TOWN OF FLOWER MOUND, TEXAS

ORDINANCE NO. 17-22

AN ORDINANCE OF THE TOWN OF FLOWER MOUND, TEXAS, AMENDING CHAPTER 14, "BUILDINGS AND BUILDING REGULATIONS," ARTICLE XIV, OF THE CODE OF ORDINANCES OF THE TOWN OF FLOWER MOUND, TO PROVIDE FOR ADOPTION OF THE *INTERNATIONAL RESIDENTIAL CODE*, 2021 EDITION, AND LOCAL AMENDMENTS THERETO; PROVIDING THAT THE BOARD OF ADJUSTMENT SHALL BE THE BOARD OF APPEALS FOR PURPOSES SET OUT HEREIN; REPEALING ALL CONFLICTING ORDINANCES; PROVIDING A SEVERABILITY CLAUSE; PROVIDING A PENALTY; PROVIDING FOR PUBLICATION; AND PROVIDING AN EFFECTIVE DATE.

FIGURE R602.6.1
Top Plate Framing to Accommodate Piping

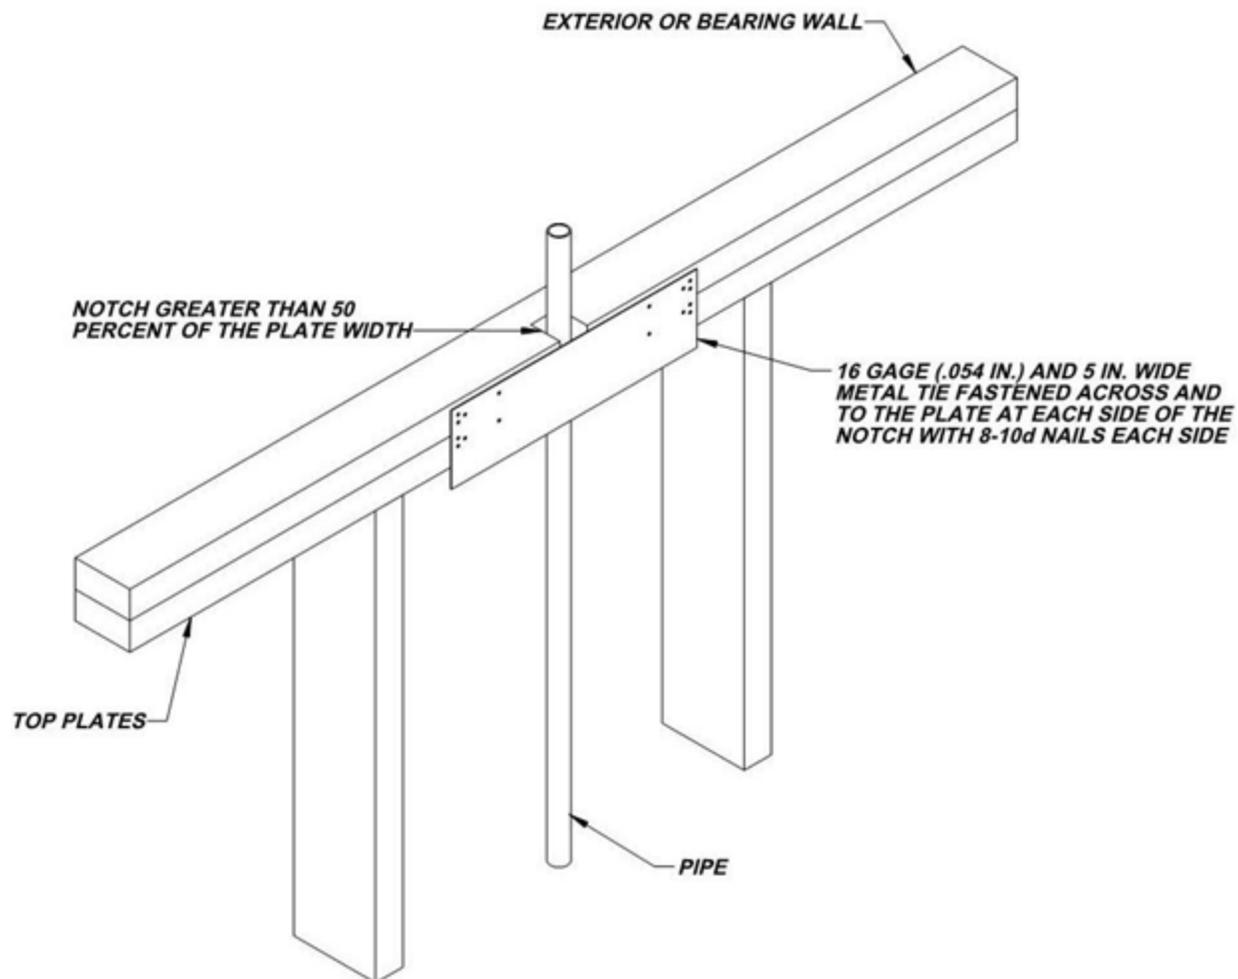
- (cc) Section R602.6.1 of the *International Residential Code*, 2021 edition, is hereby amended, the Exception is deleted in its entirety, and Figure R602.6.1 is replaced with a new Figure R602.6.1, entitled "Top Plate Framing to Accommodate Piping" to read as follows:

Section R602.6.1 Drilling and notching of top plate. When piping or ductwork is placed in or partly in an exterior wall or interior load-bearing wall, necessitating cutting, drilling, or notching of the top plate by more than 50 percent of its width, a galvanized metal tie not less than 0.054 inch thick (1.37 mm) (16 Ga) and 5 inches (127 mm) wide shall be fastened across and to the plate at each side of the opening with not less than eight 10d (0.148 inch diameter) having a minimum length of 1 ½ inches (38 mm) at each side of the notch to the first nail hole or equivalent. Fasteners will be offset to prevent splitting of the top plate material. The metal tie must extend a minimum of 6 inches past the opening. See figure R602.6.1.

Exception: Deleted.
